February 9, 2018

**Re: Natural Gas Combined Cycle Minor Modification  
Electric Transmission Line and Storm Outfalls Rehabilitation  
NPDES Permit #: PAC060046  
BCCD Project ID #: ESP-00731  
Dawood Project No. 216040.01**

Enclosed, please find revised documents for the above-referenced project updated per comments received from the DEP Chapter 105 permitting review. These documents have been revised to adjust the location of construction fence and supply additional information regarding the areas with equipment and grubbing restrictions. In addition, work associated with outfall 1 has been removed from the project as it is not required and additional notes concerning construction monitoring and waste management have been added.

DATE	JANUARY 12, 2017
JOB NO.	216040.01
FILE NAME	LDP-FL-ES01
SCALE	AS SHOWN
DRAWN BY	TRS
CHECKED BY	JTP
SHEET NO	B101

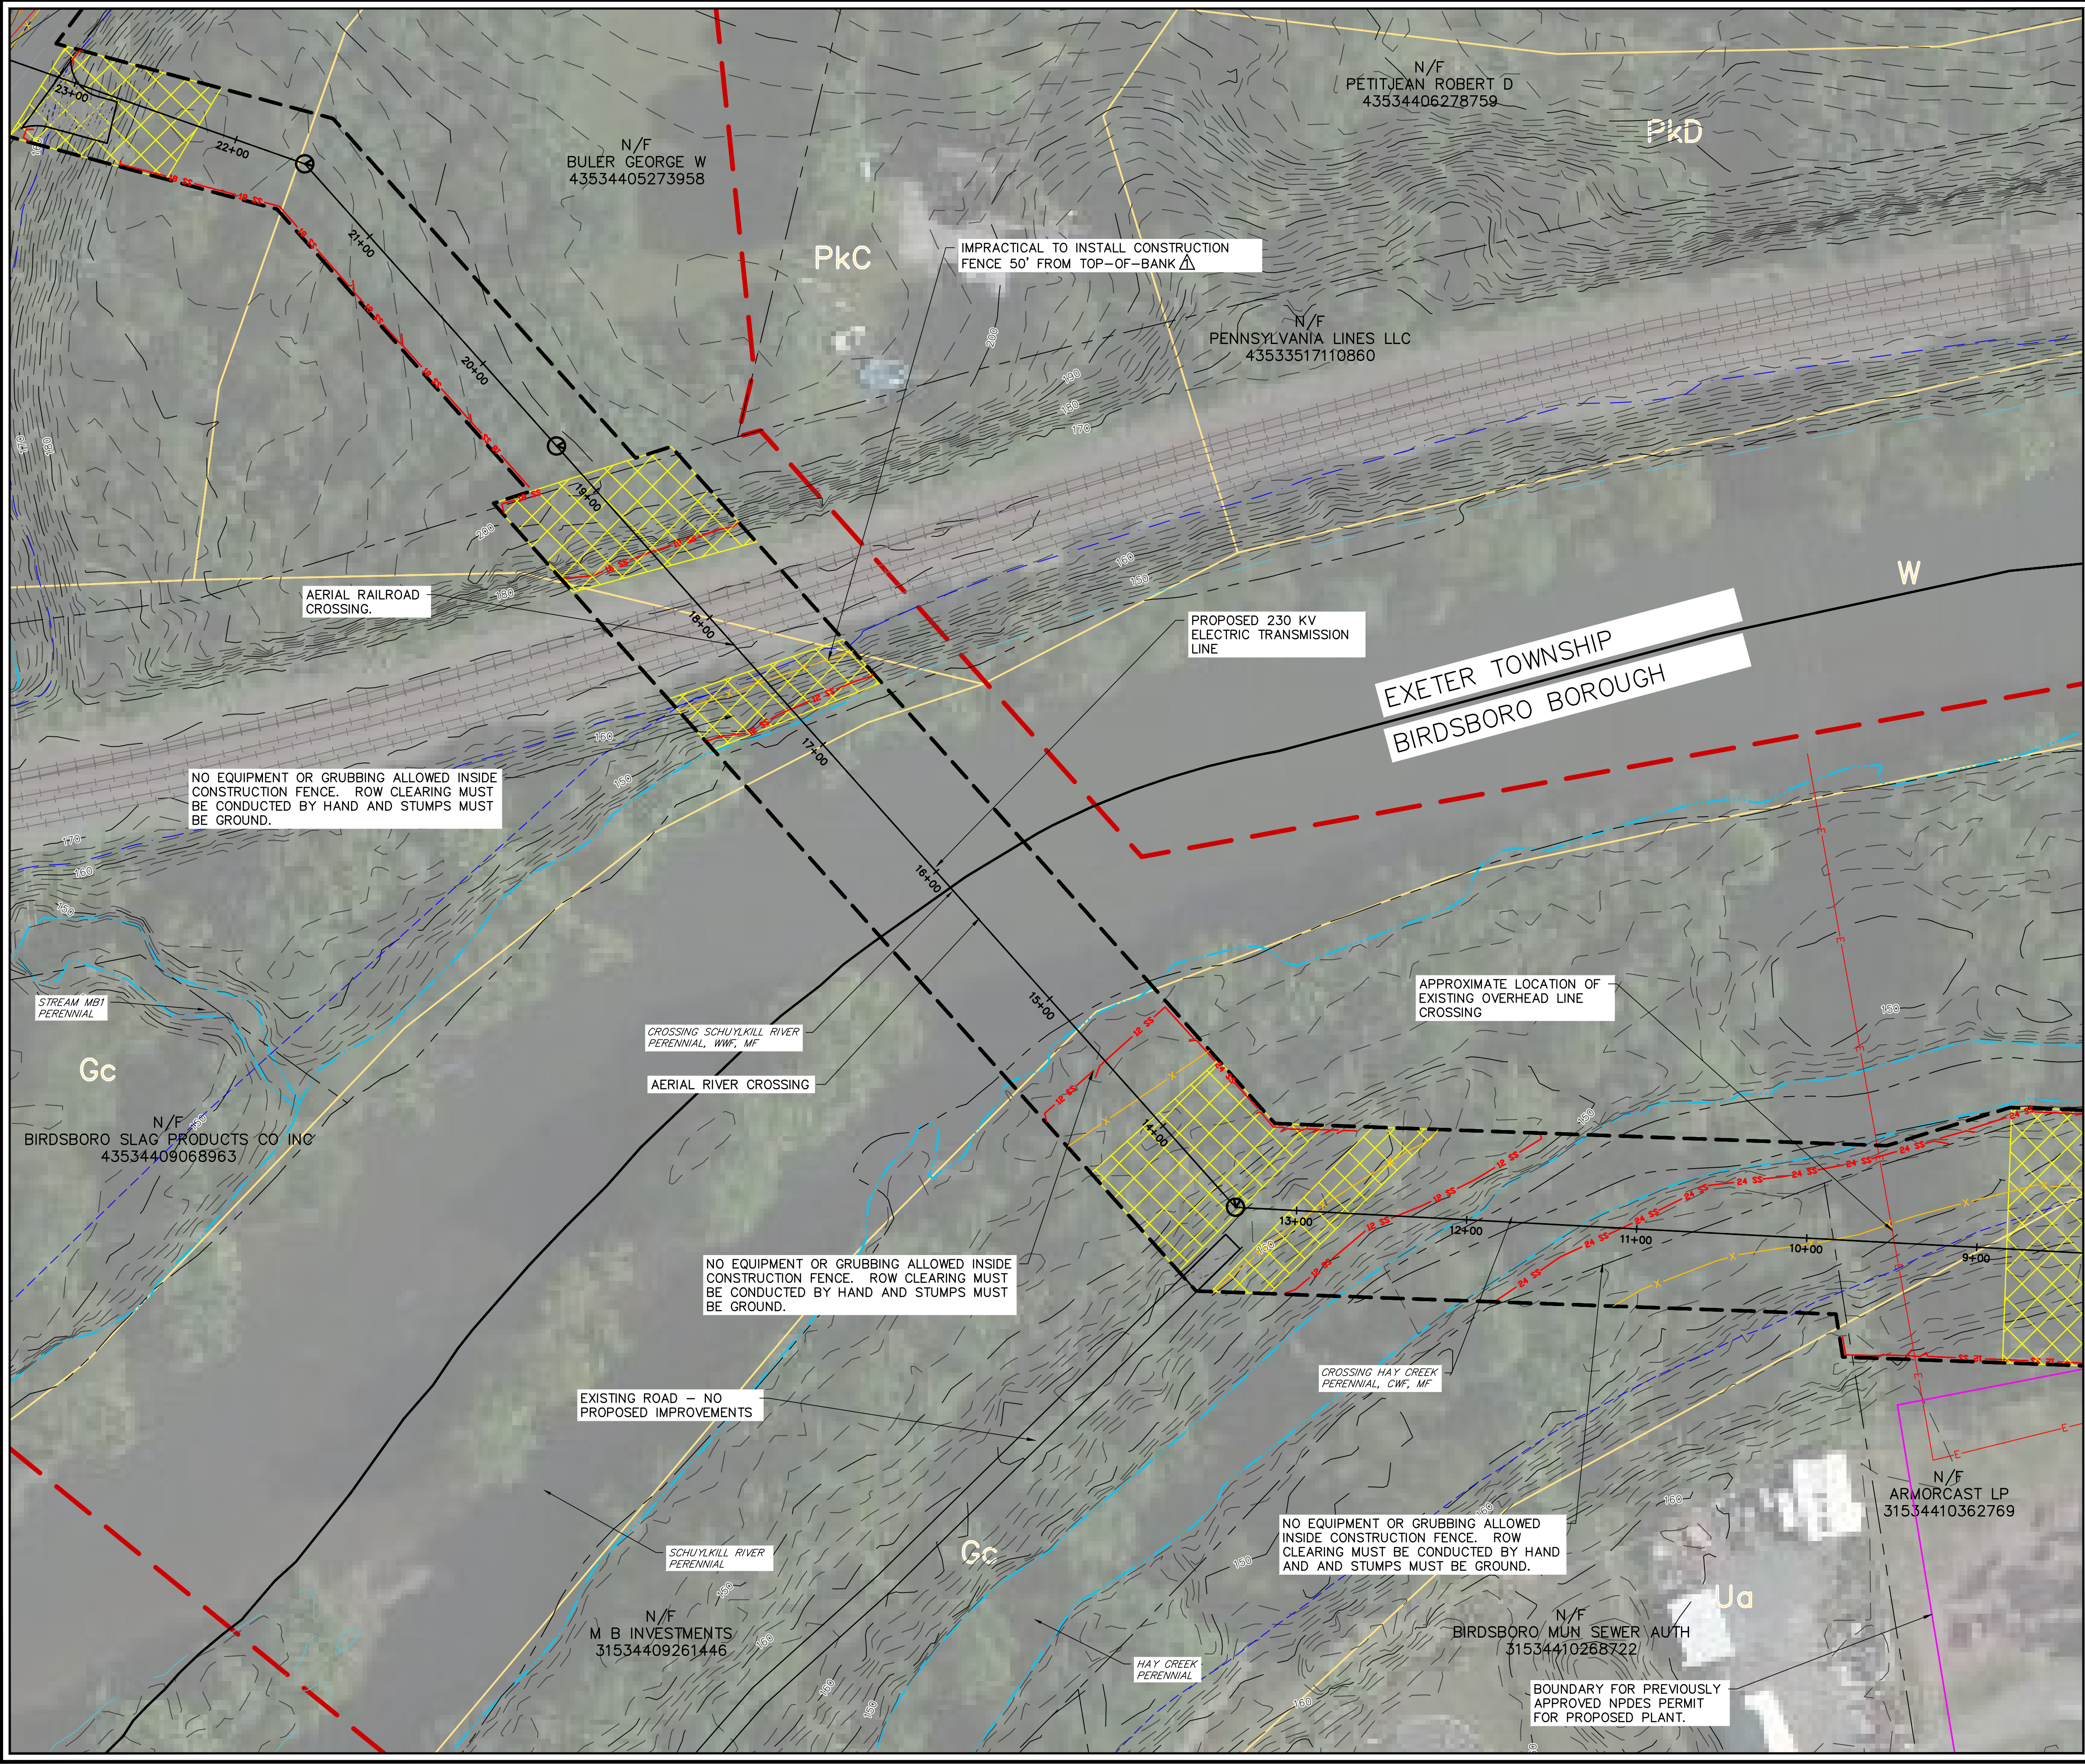
2. ESCP B100 (Page 399)– Key has been added for annotations concerning construction fence locations. Outfall 1 has been removed from the map.
3. ESCP B101 (Page 400)– Additional area has been added where no equipment or grubbing is allowed. Outfall 1 work area has been removed. No change in silt sock or limit of disturbance.

DATE	JANUARY 12, 2017
JOB NO.	216040.01
FILE NAME	LDP-FL-ES01
SCALE	AS SHOWN
DRAWN BY	TRS
CHECKED BY	JTP
SHEET NO	B102

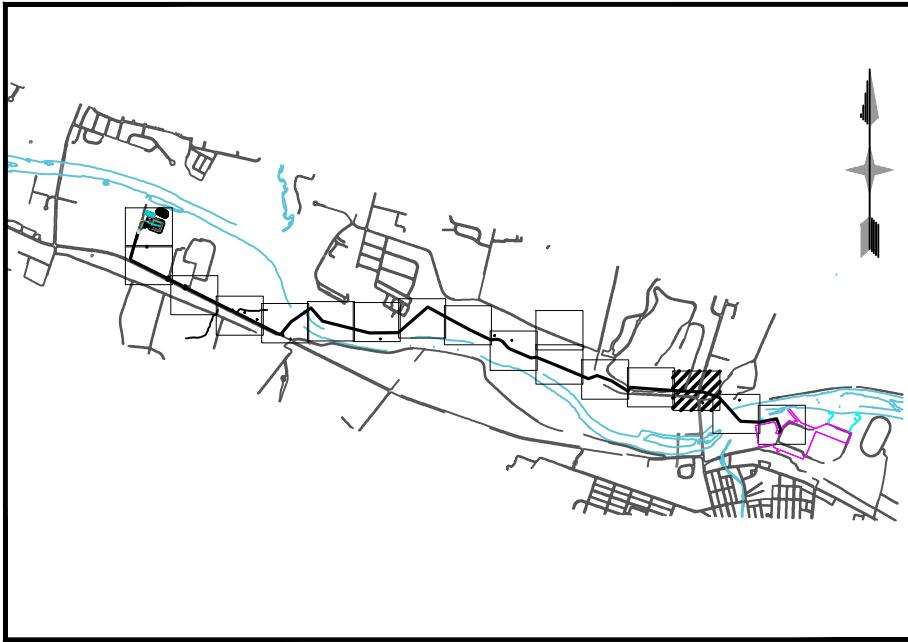
4. ESCP B102 (Page 401)– Additional area has been added where no equipment or grubbing is allowed. Annotation has been added regarding construction fence placement.

DATE	JANUARY 12, 2017
JOB NO.	216040.01
FILE NAME	LDP-FL-ES01
SCALE	AS SHOWN
DRAWN BY	TRS
CHECKED BY	JTP
SHEET NO	B103

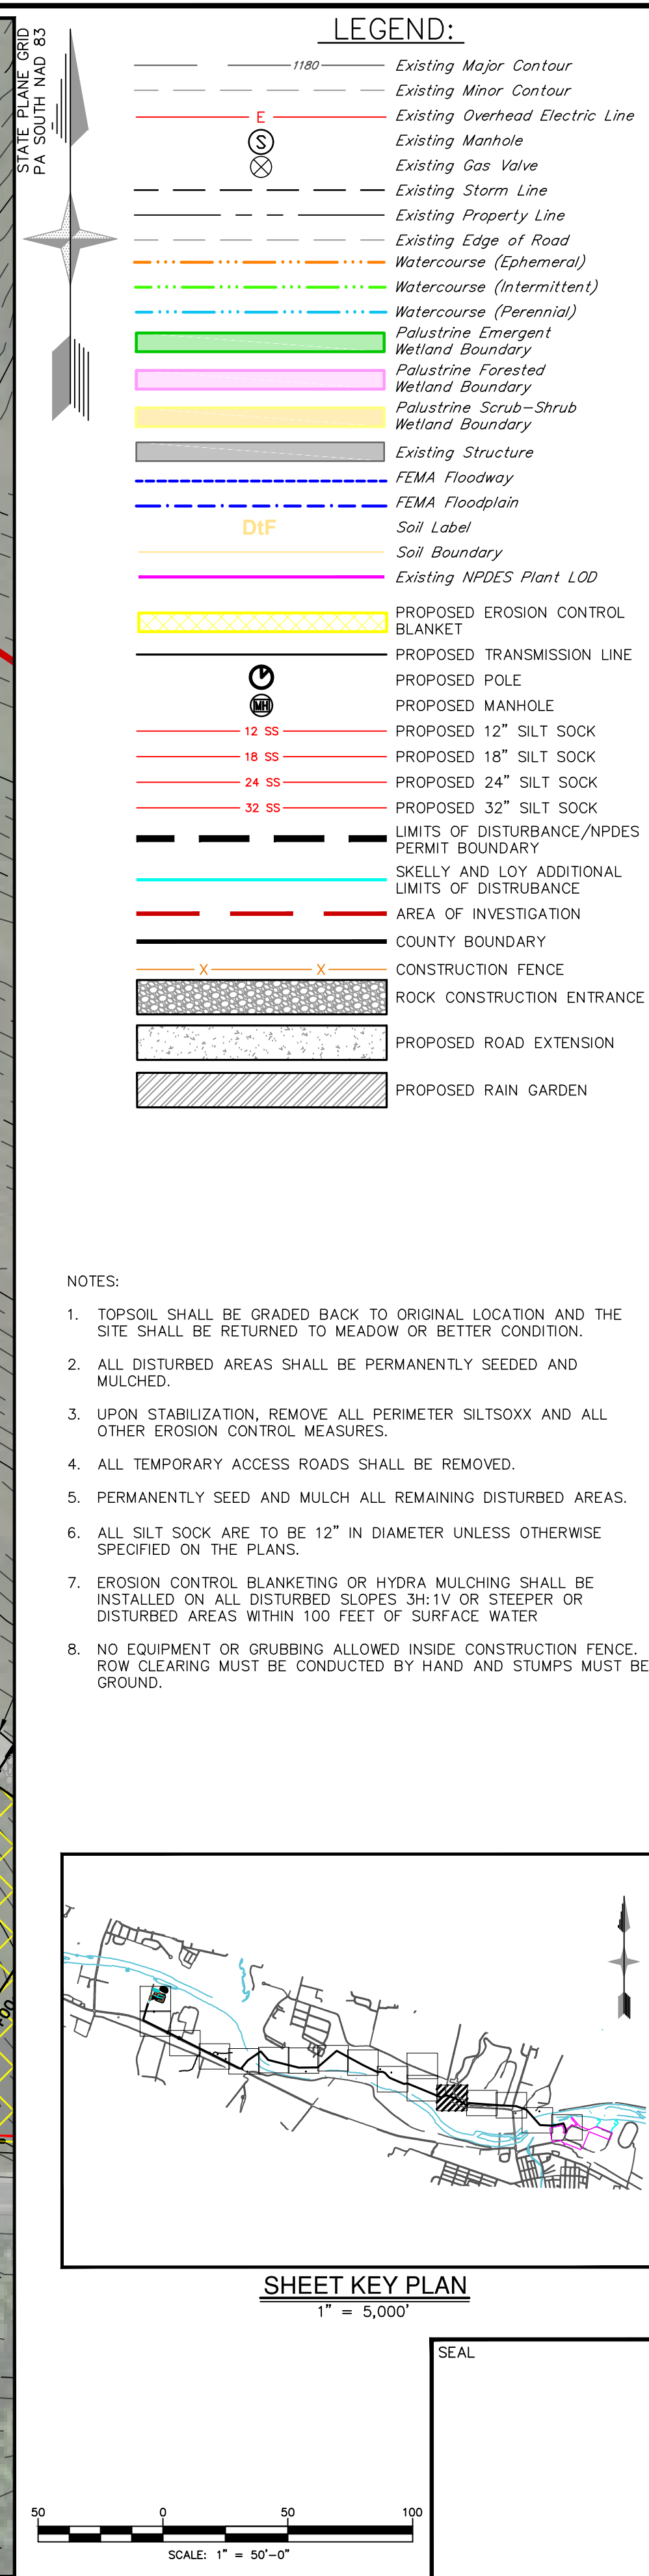
5. ESCP B103 (Page 402)– Additional area has been added where no equipment or grubbing is allowed. Annotation has been added regarding construction fence placement.

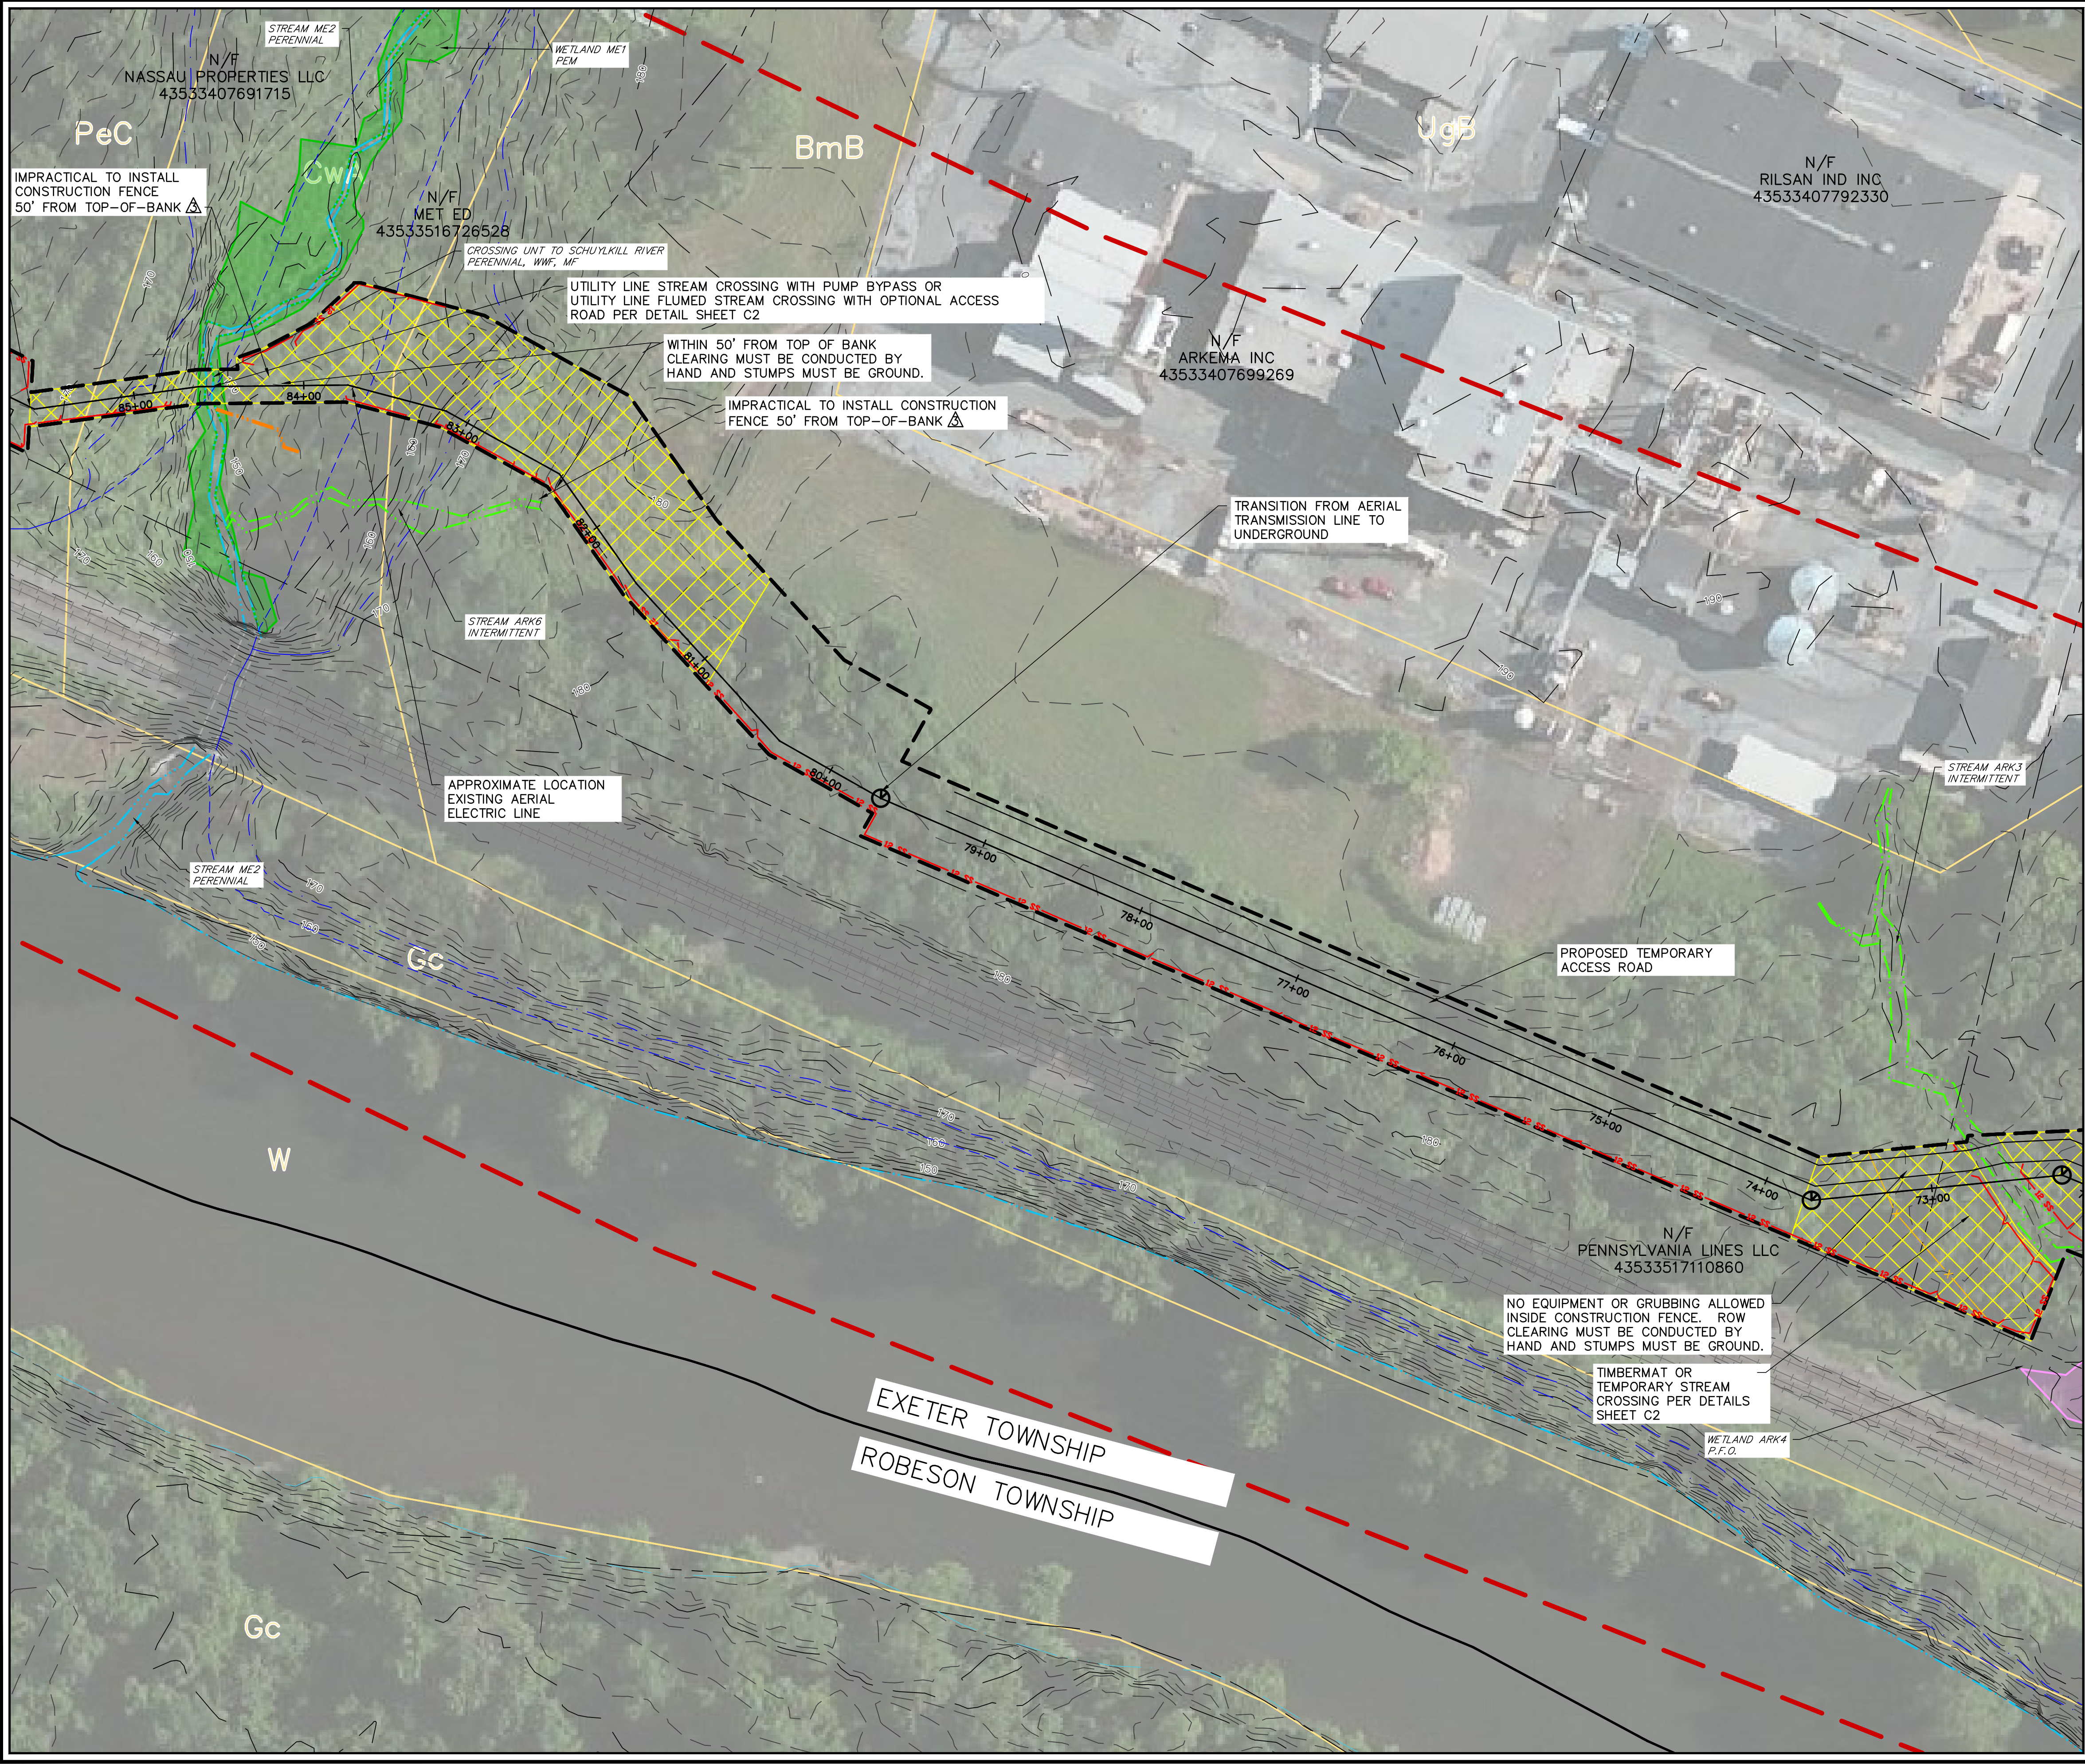
6. ESCP B105 (Page 404)– Additional area has been added where no equipment or grubbing is allowed.
